NOTICE OF DECISION

DECISION OF THE PLANNING COMMISSION

**FAIRVIEW REFINEMENT PLAN / PARTITION / PHASED SUBDIVISION CASE
NO. FRP-PAR-SUB14-01**

APPLICATION NOS.: 14-111666-ZO, 14-111667-LD & 14-111665-LD

Figure 4: Typical Street Sections

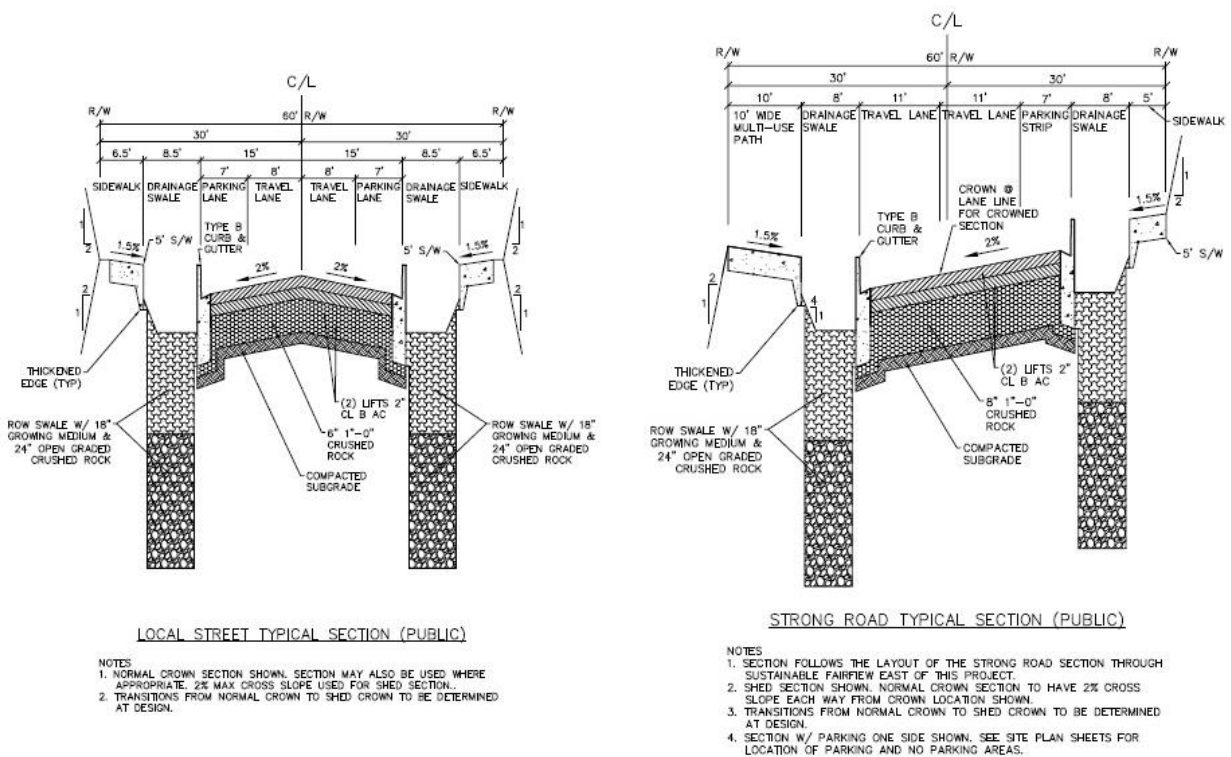
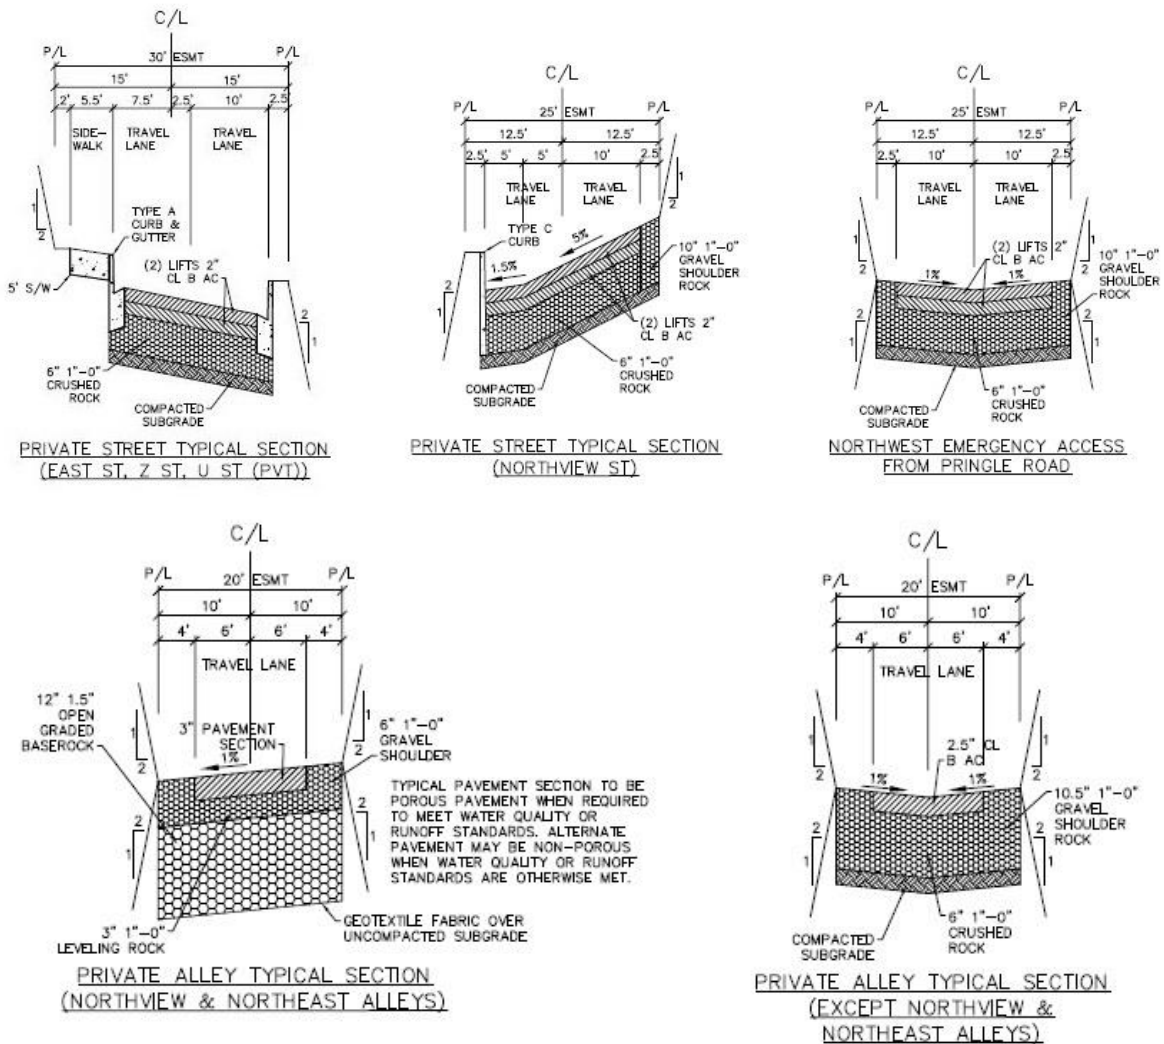
Condition 1: The third paragraph of the refinement plan, under Section 4 (Typical Street Sections) on page 16, shall be amended to read as follows:

Condition 2: The refinement plan shall be amended to remove pavement, crushed rock, and other sub-grade dimensions from the street cross sections included under Section 4 (Typical Street Sections).

"Please refer to the following diagrams in Figure 4 for typical road cross sections. Note that subbase and drainage rock will vary according to specific site conditions. Final structural street sections are addressed by the Public Works Design Standards and will be determined at the time of final design."

STRONG ROAD TYPICAL SECTION (PUBLIC)

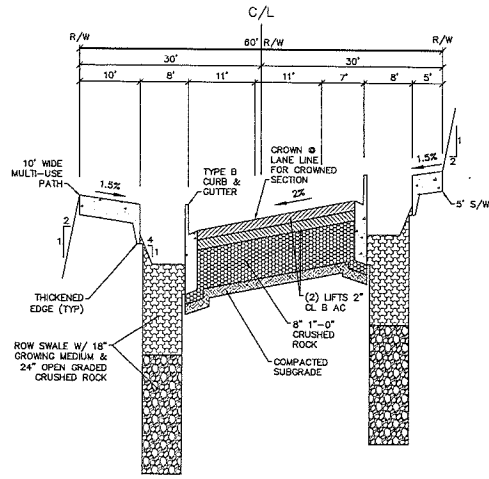
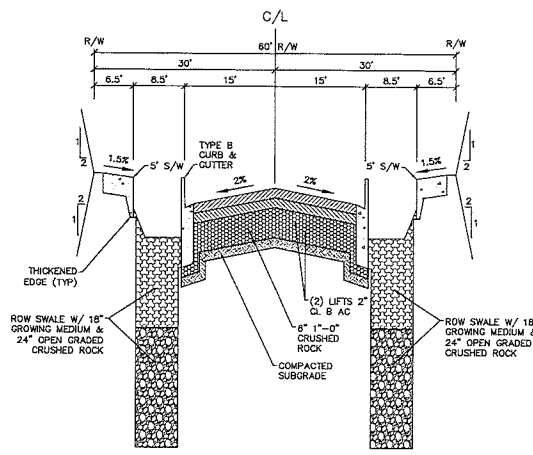
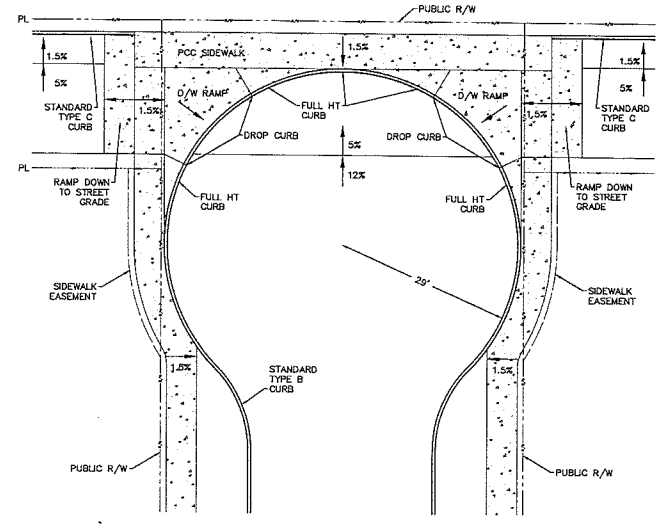
- a. Realign the centerline of 1st Street to align with the 1st Street centerline in the adjacent Simpson Hills Refinement Plan.
- b. Show a minimum 24-foot curb-to-curb width along the entire length of Strong Road SE.
- c. Provide a pavement width at Strong Road SE between Q Street and Pringle Road SE sufficient to install a right turn lane to Pringle Road SE and a taper to 24 feet at Q Street.
- d. Provide a 50-foot centerline radius with a commercial driveway approach on Z Street at the intersection of Z Street and 2nd Street. An alternative design may be approved by the Public Works Director.
